EPA-SAB-10-006

Subject: SAB Review of Empirical Approaches for Nutrient Criteria Derivation

EPA's Office of Water (OW) requested that the Science Advisory Board (SAB) review the Agency's draft guidance document titled *Empirical Approaches for Nutrient Criteria Derivation* ("Guidance"). The Guidance is one of a series of technical documents developed by OW to describe approaches and methods for developing numeric criteria for nutrients. The Guidance specifically focuses on empirical approaches for determining stressor-response relationships to derive numeric nutrient criteria. In response to the Agency's advisory request, the SAB Ecological Processes and Effects Committee, augmented with additional experts, met on September 9-11, 2009 to conduct a peer review of the Guidance. OW requested that the SAB: 1) comment on the technical merit of the methods and approaches described in the Guidance; 2) suggest approaches that might be considered to improve the Guidance; and 3) offer suggestions to improve the utility of the Guidance for state and tribal water quality scientists and resource managers. The enclosed advisory report provides the advice and recommendations of the Committee.

Figure 1. EPA's Framework for Developing Nutrient Criteria Based on Stressor-Response Relationships and SAB Recommendations for Revision

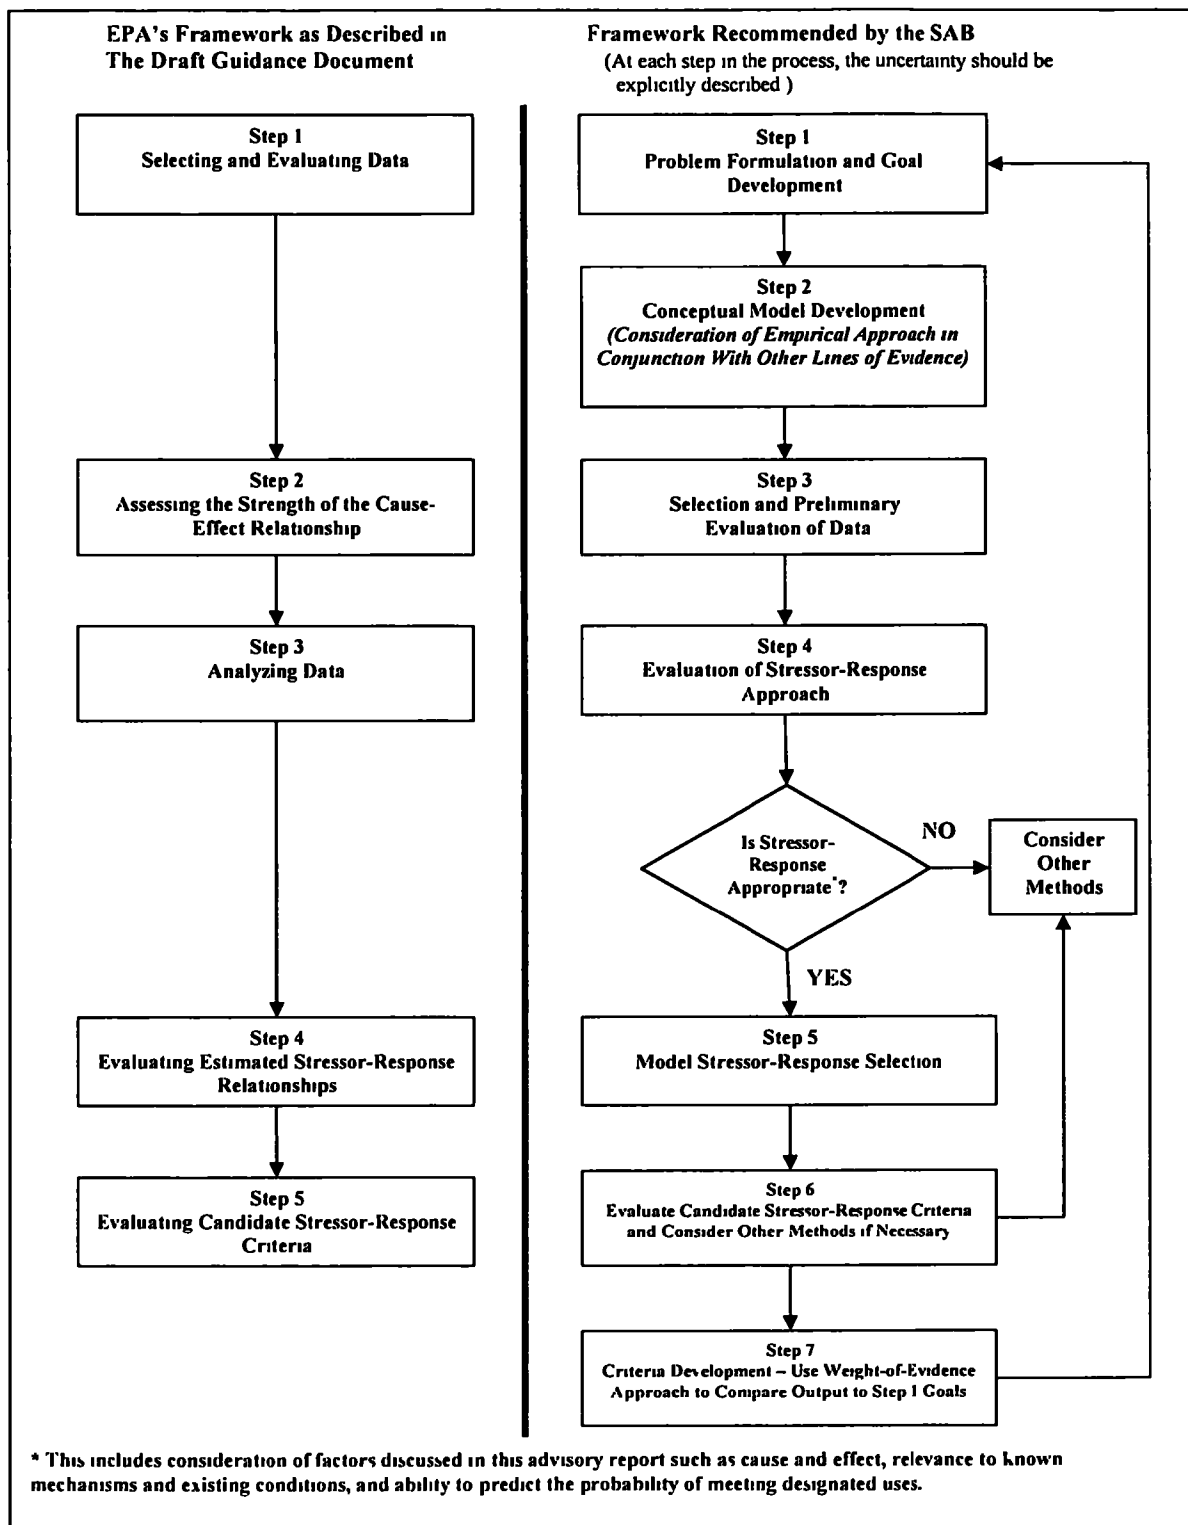
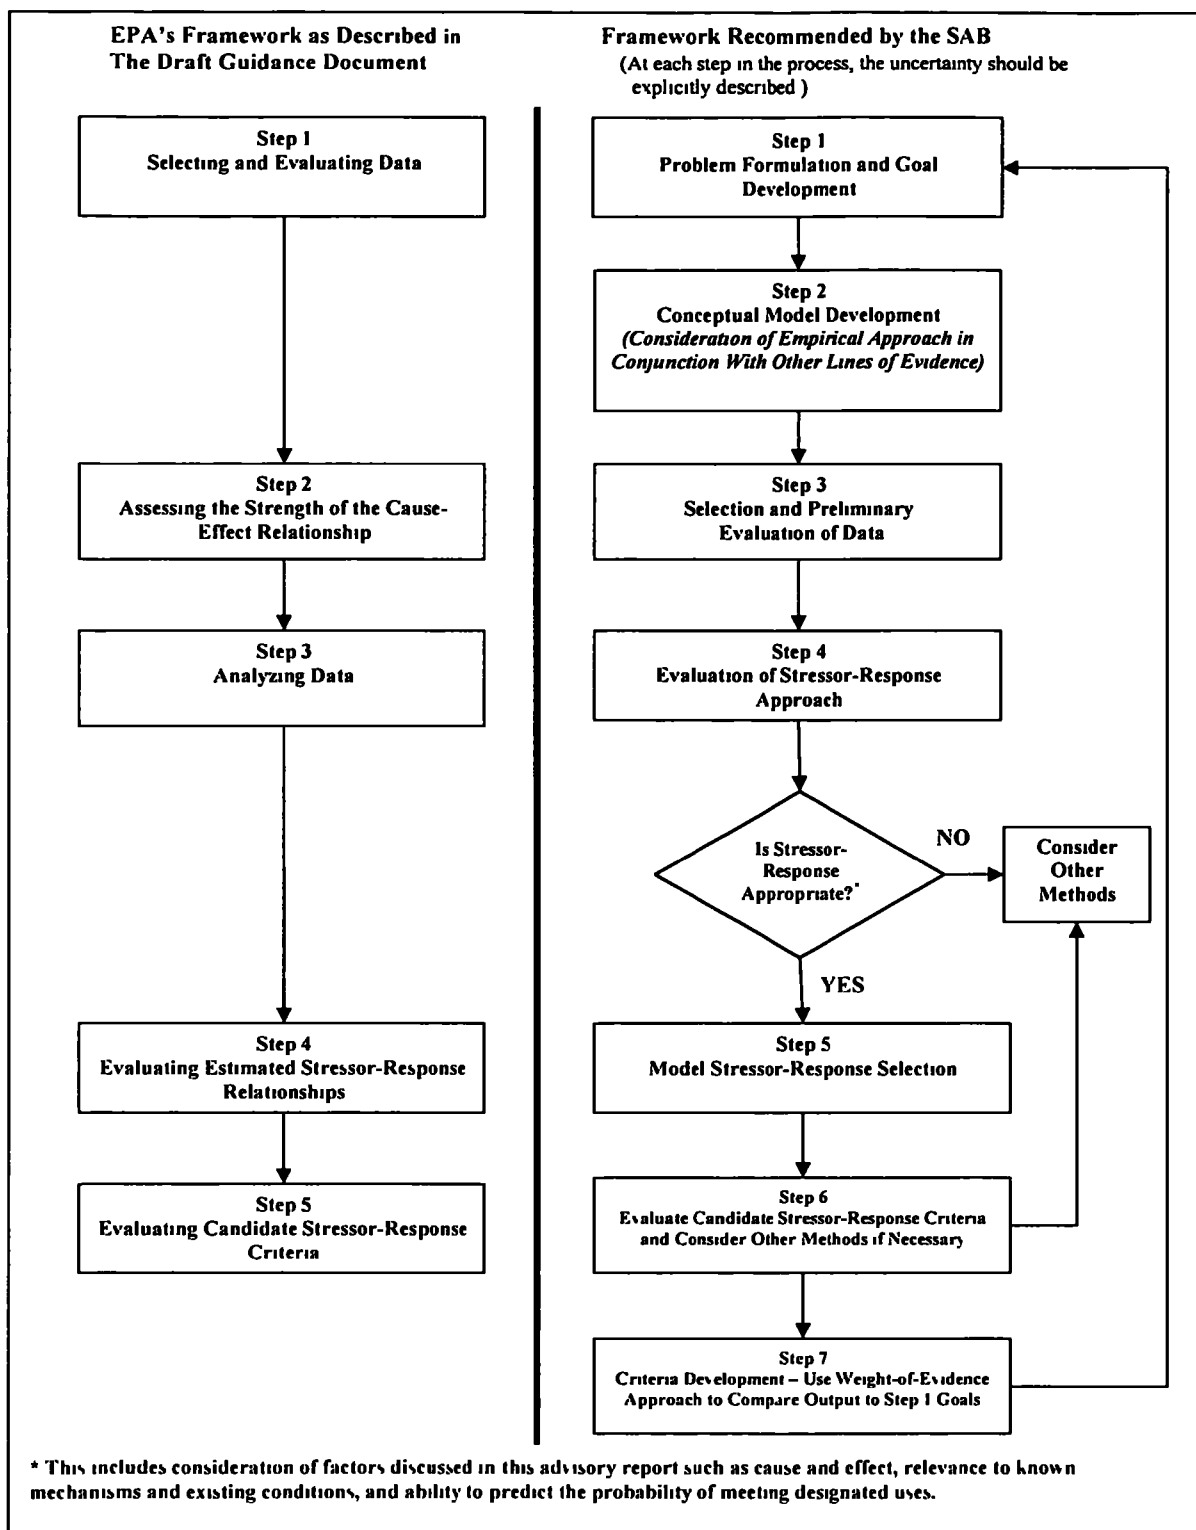
- The Committee finds that the Guidance: 1) should provide a more specific and descriptive framework outlining the steps in the criteria development process (Figure 1 of this advisory report illustrates EPA's proposed framework for developing nutrient criteria and the SAB recommendations for revision of the framework); 2) must be detailed and sophisticated enough to ensure statistical rigor, but additional support must also be provided by EPA to help users meet the technical demands of the methods; 3) should more clearly express the caveats and limitations of the statistical methods and approaches in the document, in particular the fact that statistical correlations do not establish cause and effect; 4) should contain more technical guidance and examples to describe when and how to use various methods and approaches; and 5) should provide additional guidance on data requirements for application of the statistical methods and approaches.

9. EPA should consider modifying the steps that provide the framework of the Guidance. The Committee suggests that the steps in the framework should be more specific and descriptive. An example is illustrated in Figure 1 of this advisory report. Two important aspects of the example in Figure 1 currently are missing from the Guidance: problem formulation/goal development and conceptual model development should be the first steps in the process, and the framework should contain an explicit step to determine whether the stressor-response relationship is appropriate.

- Conceptual model development should be required and should be incorporated early in the process of criteria development (see Figure 1 of this advisory report). Conceptual models are an important component in selection of response variables. Any stressor-response relationship used in criteria development must have ecological relevance (based on ecological understanding of the system) that can be readily explained and defended as discussed in step two in the Guidance. Conceptual models based on past empirical and experimental studies are important for identifying the mechanisms responsible for responses and effectively communicating this linkage. In the framework suggested by the Committee (Figure 1), developing the conceptual model is the second step in the process. [See the responses to Charge Questions 4 and 6 for additional discussion.]

- The Guidance would be more effective if exploratory data analysis were included by itself in a separate section of the document following a major section on problem formulation (corresponding to the Framework in Figure 1 of this advisory report).
